Upper Seagry – Commercial FRA Addendum (October 2025)

A Flood Risk Assessment (FRA) including a drainage strategy was provided in July 2025 with the planning application for the proposed development of land at Seagry House located off Henn Lane and Startley Road, Upper Seagry, Chippenham, SN15 5HD. The planning application number is PL/2025/06615.

Wiltshire Council (WC) as the Local Planning Authority (LPA) and Lead Local Flood Authority (LLFA) provided comments on the FRA, which required the provision of additional information to demonstrate compliance with the National Standards for SuDS (2025). These comments have been addressed in our response as below.

Drainage Strategy Plan (Drawing PDL-01 Revision D)

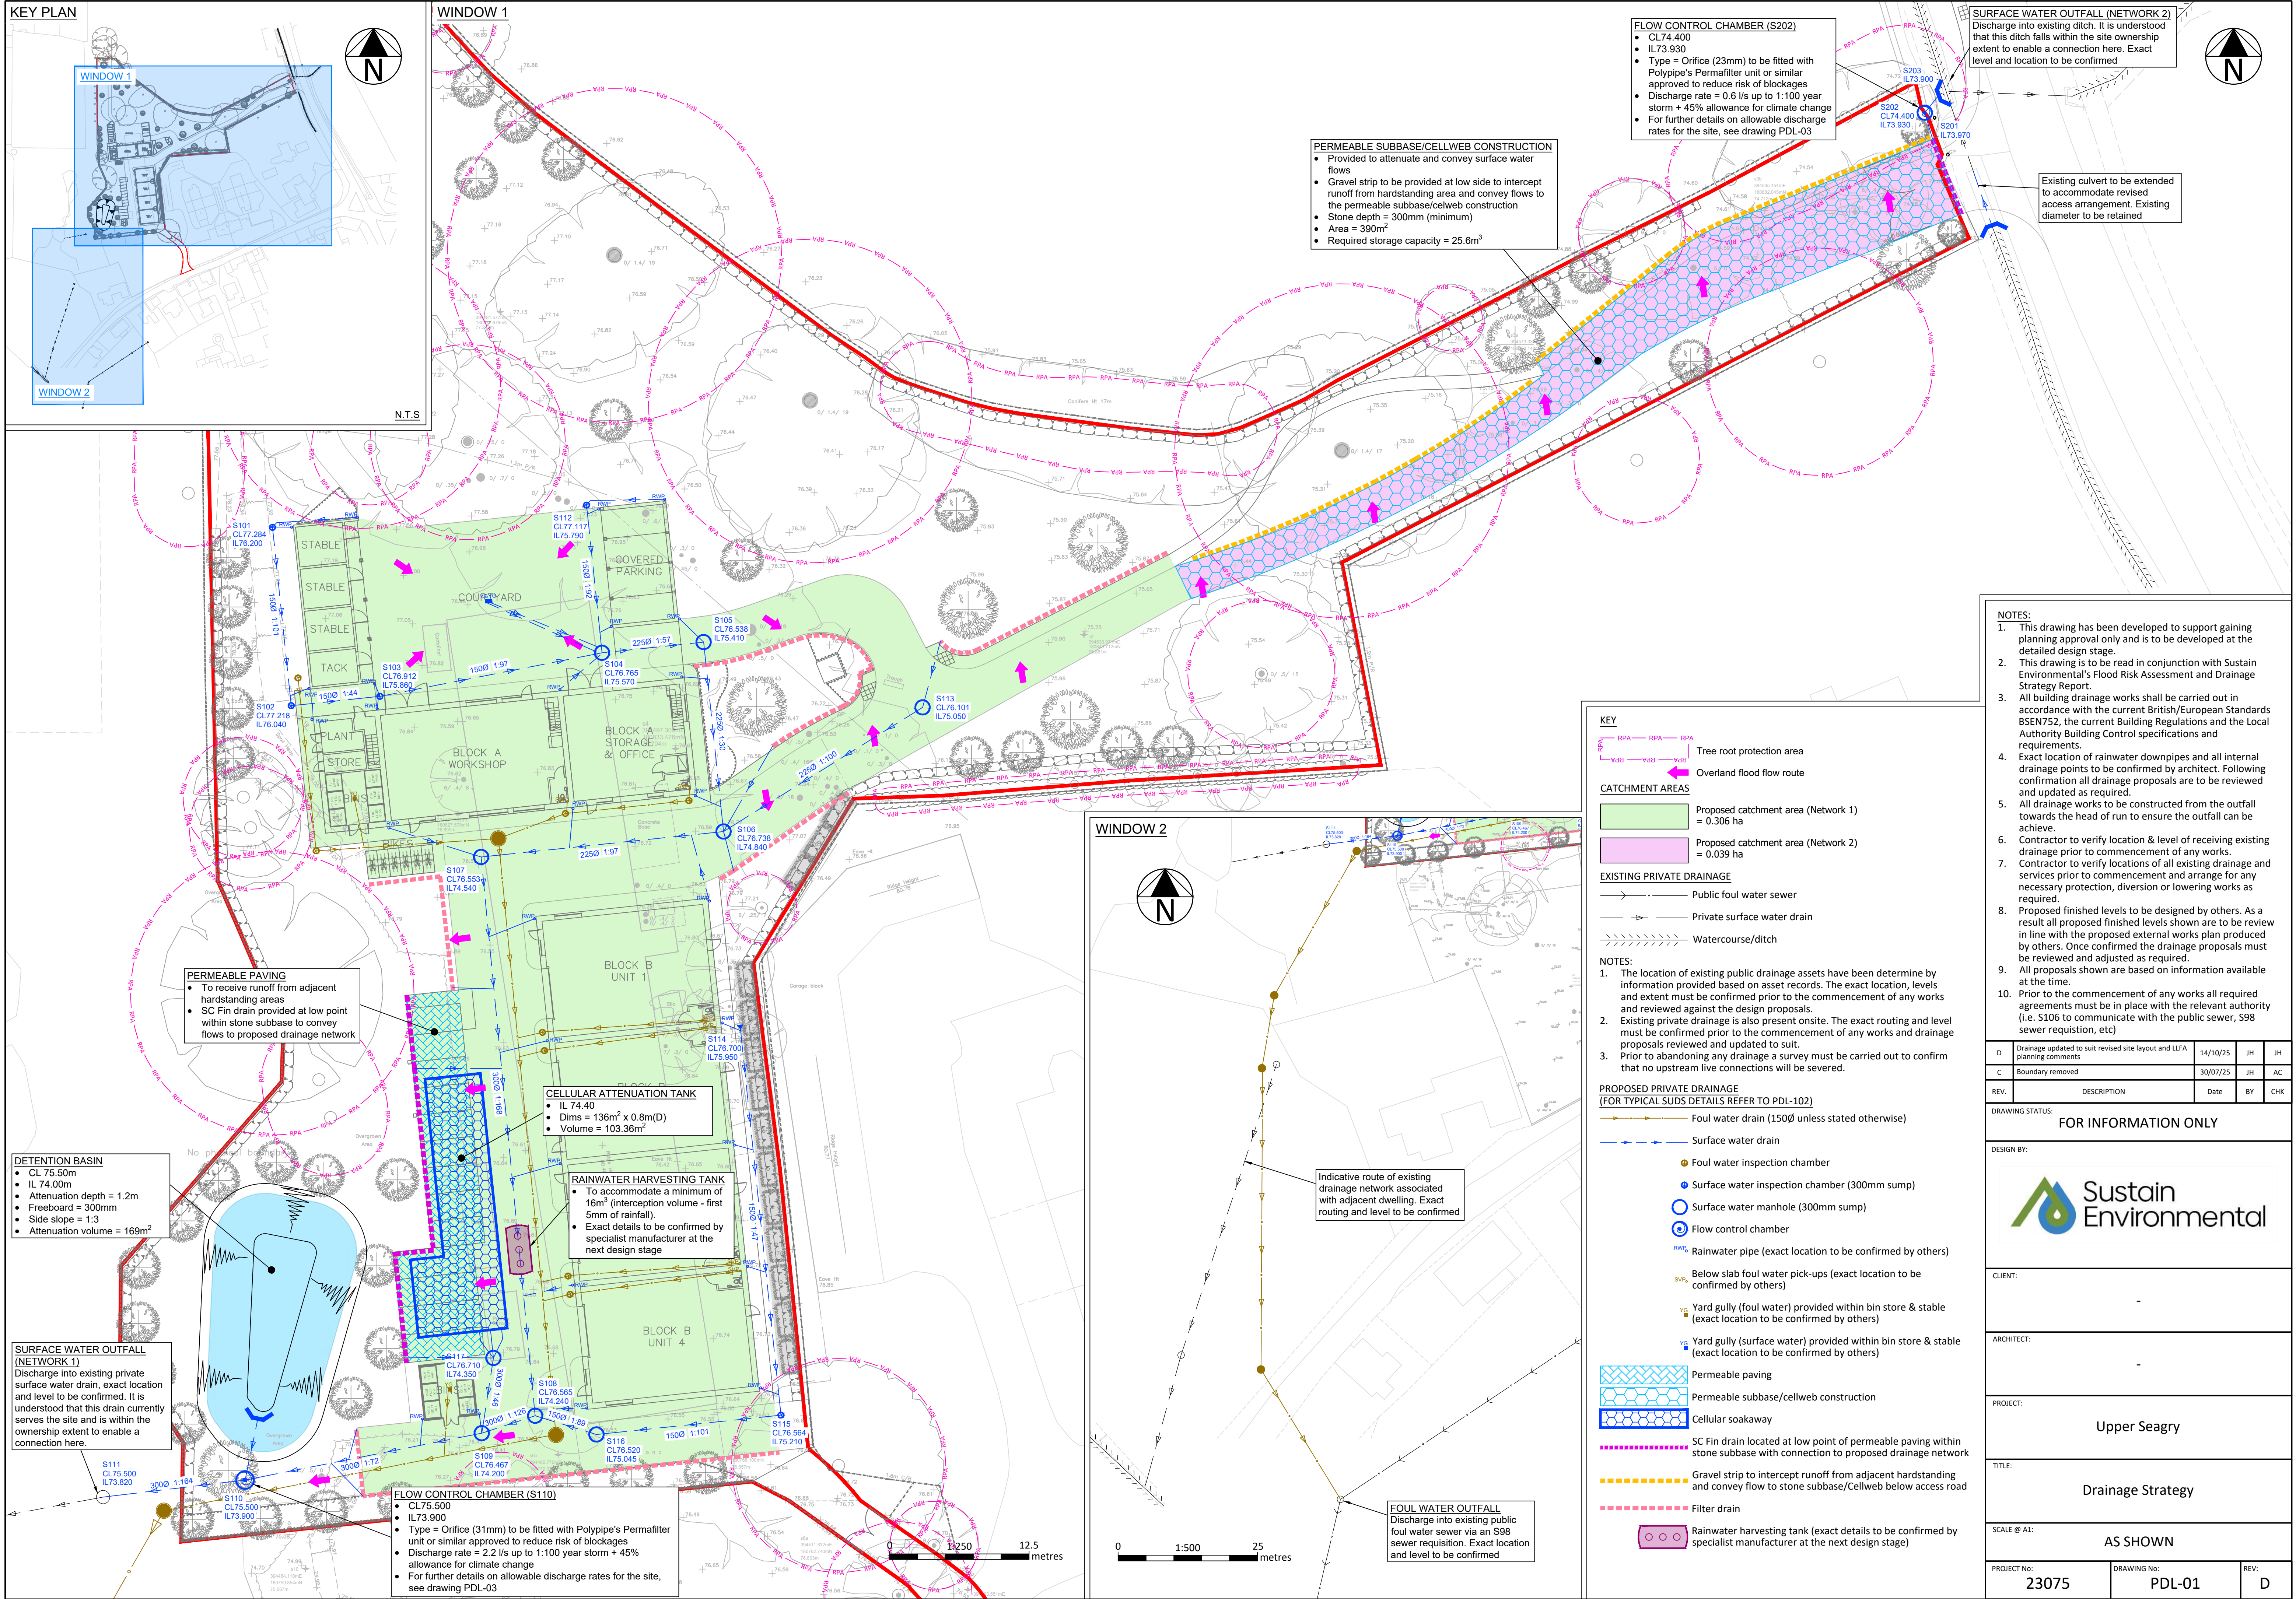
“The applicant is required to confirm whether a Rainwater Harvesting (RWH) system will be included in the proposed design, and to provide further details regarding its planned implementation.”

“A demonstration of the inclusion and arrangement of interception storage features in accordance with Standard 2 of the National Standards for SuDS. Evidence and calculations shall be provided to demonstrate that the runoff from each positively drained surface, for at least 5mm of rainfall, is either collected for use, or else captured, conveyed and stored within SuDS features.”

“The submitted exceedance flow routing does not match the levels shown on the topographic survey in all locations. The applicant should confirm whether any re-levelling is planned to facilitate exceedance routing, and submit any supporting plans where required.”

"Flow Control Chambers rely on Ø25–26 mm orifices which are very small for surface-water controls and are prone to blockage/silting/icing. Many adopters/LLFAs typically look for ≥75 mm (some prefer ≥100 mm)."

The amended drainage strategy plan (Drawing PDL-01 Revision D) has been included as Appendix A and the updated drainage strategy calculations are included as Appendix B. Typical details of the proposed SuDS features (Drawing PDL-02 Revision B) are included as Appendix C. The requested drainage catchment assessment (Drawing PDL-03 Revision A) has been included as Appendix D.

The drainage strategy plan included as Appendix A shows the two drainage catchments of the post-development layout with the majority of the site draining to the west / south-west (0.306ha) and with a smaller area draining to the east (0.039ha).

Overland flow routes are denoted using pink arrows on the drainage strategy plan. These are the overland flow routes for storm events that exceed the design standards of the drainage strategy.

We have added notes on the proposed flow control chambers. A low flow rate is required from the site to meet with the drainage requirements and comments. We are not therefore able to avoid having a low flow rate. We have proposed including Polypipe's Permafilter unit (or similar approved) to reduce the risk of blockages, as shown on the drainage plan (Appendix A) and typical SuDS details (Appendix C).

We have shown on the drainage strategy plan the areas of permeable paving / sub-base. We also show the proposed rainfall harvesting tank. This feature has a minimum volume of 16m³ and would provide the requested interception storage volume for the 5mm of rainfall. Additional interception storage would be provided by the permeable paving / sub-base and by the and the filter drain / gravel strip.

The detention basin is shown on the drainage strategy plan. There is a slight increase to the extent of this drainage feature to increase the volume from 155m³ to 169m³ – to enable us to address the comments.

As noted above – a rainwater harvesting system will be included, as shown in Appendix A.

As noted above – interception storage would be provided through inclusion of a rainwater harvesting system and by the inclusion of permeable paving / sub-base and the filter drain / gravel strip.

As noted above – overland flow routes are denoted using pink arrows on the drainage strategy plan. These are the overland flow routes for rainfall events that exceed the design standards of the drainage strategy.

The drainage strategy would be privately owned and maintained. We are therefore not reliant on the system being adopted. However, to achieve the runoff rates that are required necessitates a restricted flow control. This is typically achieved through inclusion of a reduced orifice size. As noted above – we have proposed including Polypipe's Permafilter unit (or similar approved) to reduce the risk of blockages.
